# **NIOSH RESPONSE TO SC&A REVIEW OF ORAUT-RPRT-0080**

**Response Paper**

January 30, 2018

This response paper is the National Institute for Occupational Safety and Health's (NIOSH) response to Sanford Cohen and Associates' (SC&A) review of ORAUT-RPRT-0080, *Potential Neptunium Exposure to Plutonium Fuel Facility Construction Workers in Building 235-F at the Savannah River Site* (SRDB 165590).

Figure 1. Air Data for Building 235-F

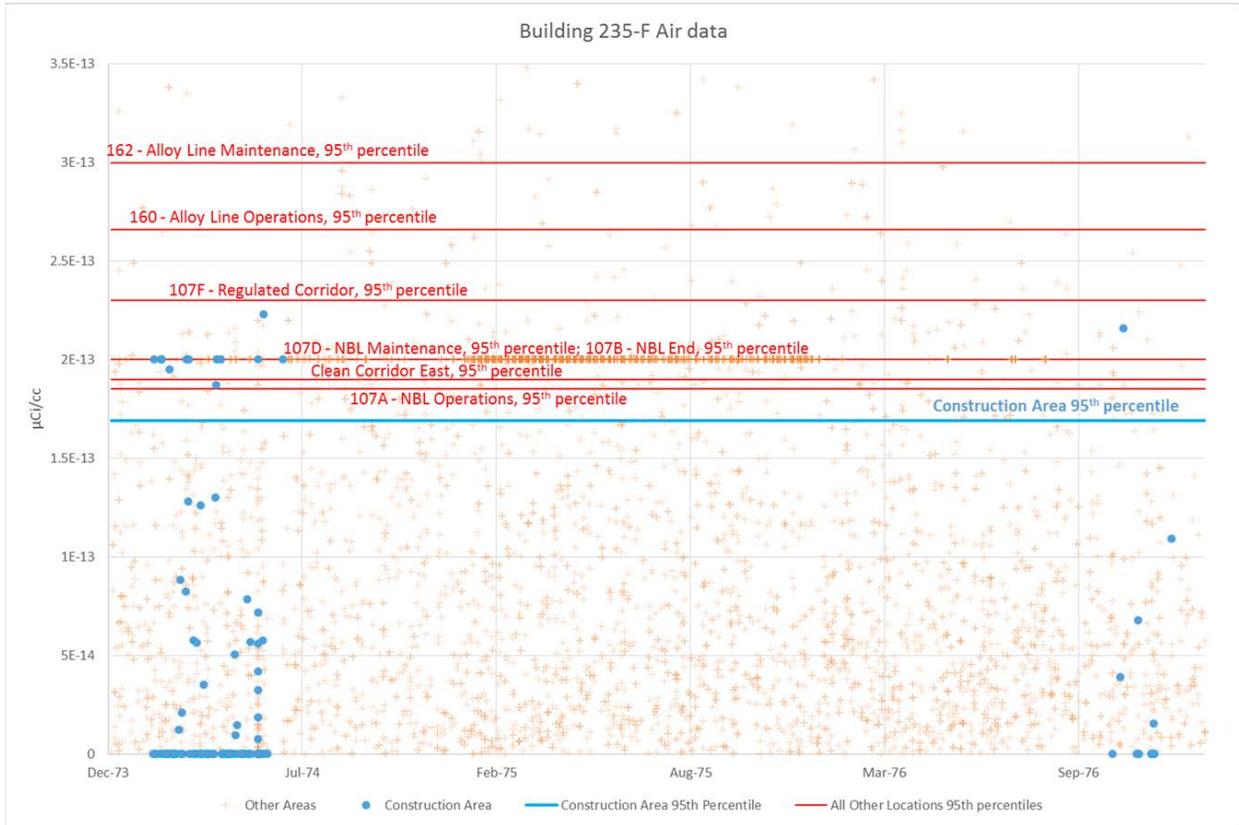
**Observation 3:** *The calculated geometric mean and 50th percentile values for available air samples in the Construction Area are comparable and/or bound the calculated air samples from the 107F – Regulated Corridor and the 107B – NBL End locations. These locations are either directly adjacent to the NBL (107F – Regulated Corridor) or inside the airlocks of the NBL (107B – NBL End).*

In their review, SC&A notes the small differences in the geometric mean (GM) and 50<sup>th</sup> percentile values for the air data results at locations nearer to the NBL and those in other areas. These summary statistics are derived from air sample results with inherent variability due to counting statistics and radioactive decay. They are presented in Table 2-3 (SRDB 165590) to show the air concentrations were, for the greatest part, low even in the areas around the NBL. The report shows that the GM and 50<sup>th</sup> percentile values for the air sample results taken in the same room as the NBL, in areas near the NBL, and in the Construction Area, were less than 2% of the site’s Radioactivity Concentration Guides.

Below in Figure 1 are plotted the air sample results used in in ORAUT-RPRT-0080. The Construction Area results are shown as blue dots. All other locations results are shown as orange crosses. The horizontal lines show the 95<sup>th</sup> percentile values from Table 2-3. Note that this graph is linear and contains data plotted as the semi-logarithmic graphs in Appendix A of the report.

The 95<sup>th</sup> percentiles are included in Table 2-3 to describe the range of the air results. The 95<sup>th</sup> percentile for the Construction Area air samples is substantially lower than the values for the air sample results in the same room as the NBL and the areas near the NBL.
